LAKE PONTCHARTRAIN, LOUISIANA AND VICINITY  
LAKE PONTCHARTRAIN BARRIER PLAN  
DESIGN MEMORANDUM NO. 2 - GENERAL DESIGN  
SUPPLEMENT NO. 5A

CITRUS LAKEFRONT LEVEE  
IHNC TO PARIS ROAD

LMVED-TD (NOD 26 May 76) 5th Ind  
SUBJECT: Lake Pontchartrain, Louisiana, and Vicinity, Lake Pontchartrain  
Barrier Plan, General Design Memorandum No. 2, Supplement  
No. 5A, Citrus Lakefront Levee, IHNC to Paris Road

SUBJECT: Lake Pontchartrain, Louisiana, and Vicinity, Lake Pontchartrain  
Barrier Plan, General Design Memorandum No. 2, Supplement No. 5A,  
Citrus Lakefront Levee, IHNC to Paris Road

INCL 4

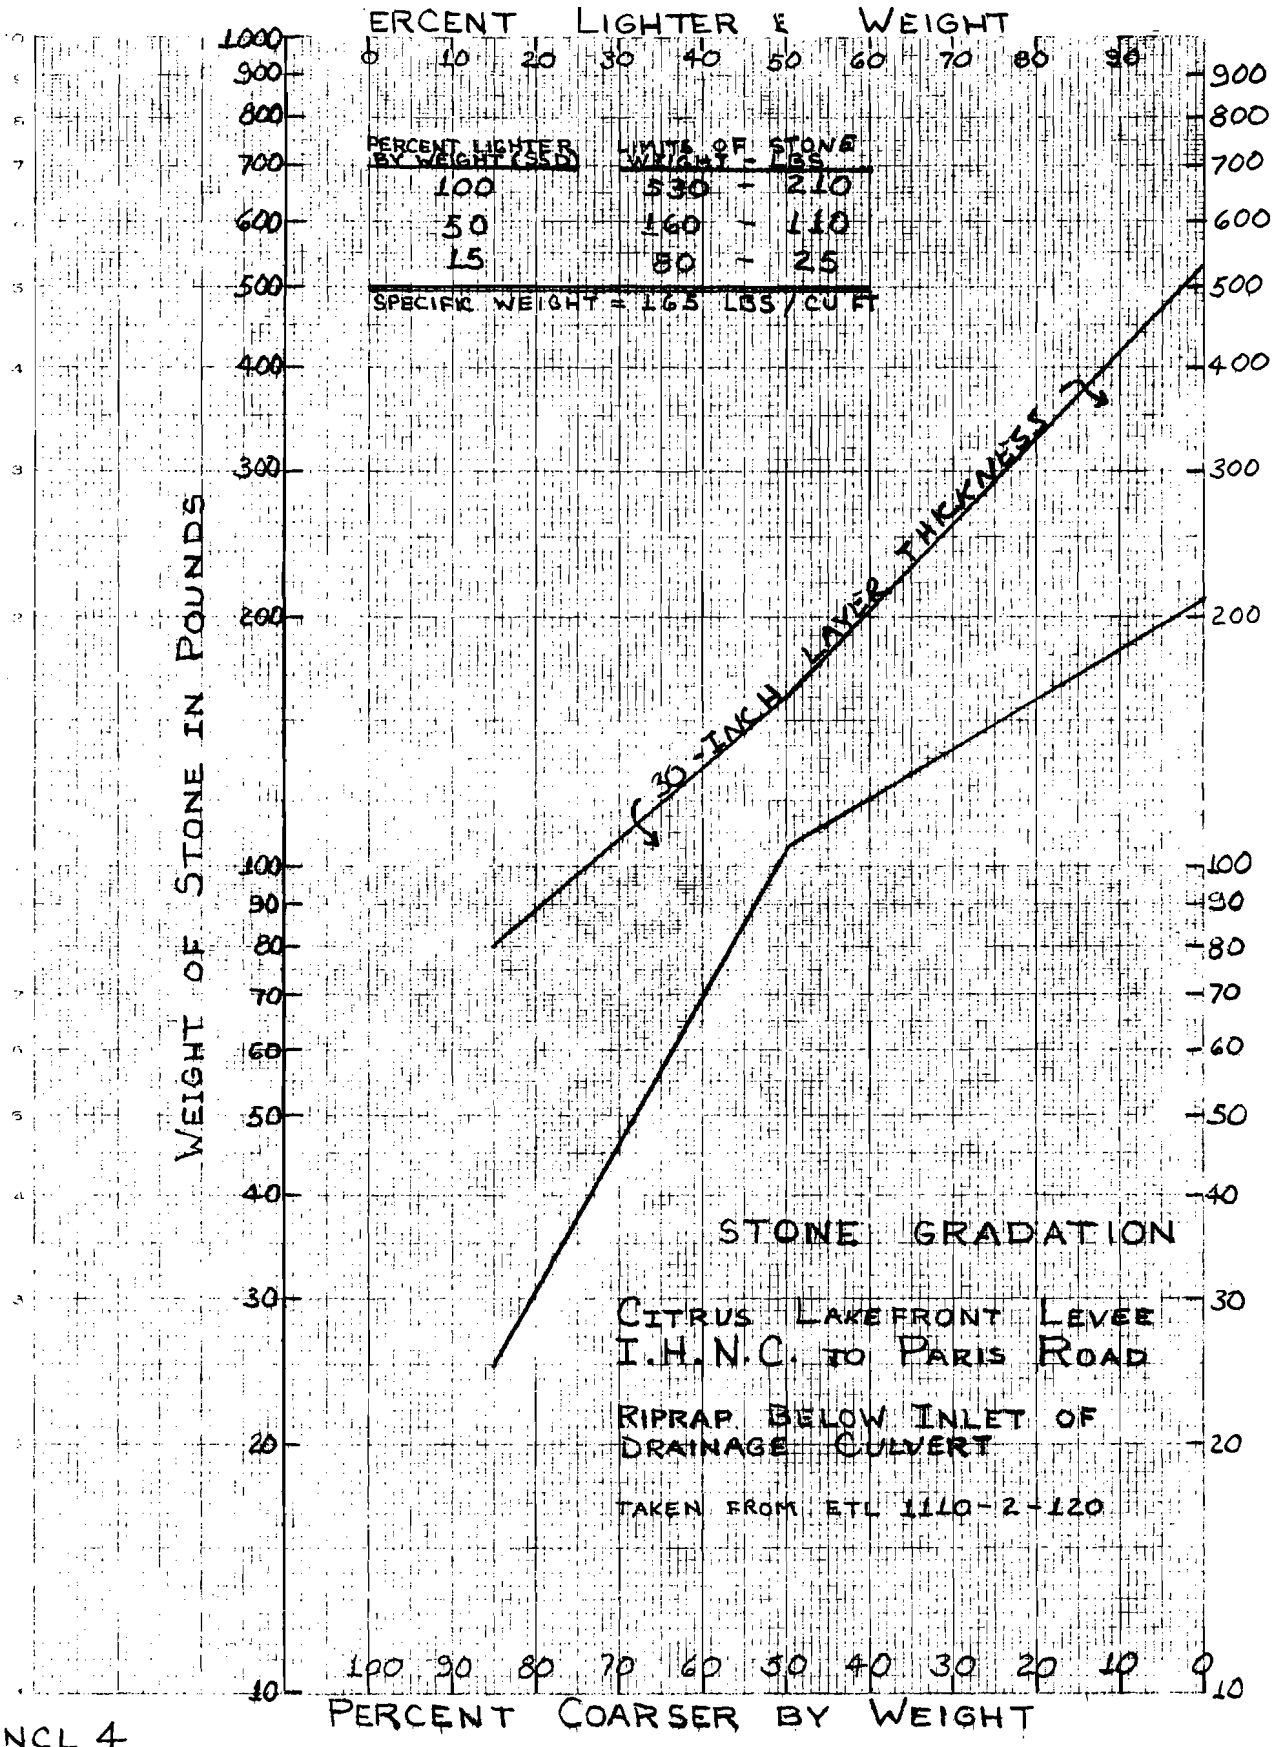
a. Para a. Concur. Inclosure 4 is a revised stone gradation curve reflecting this change.
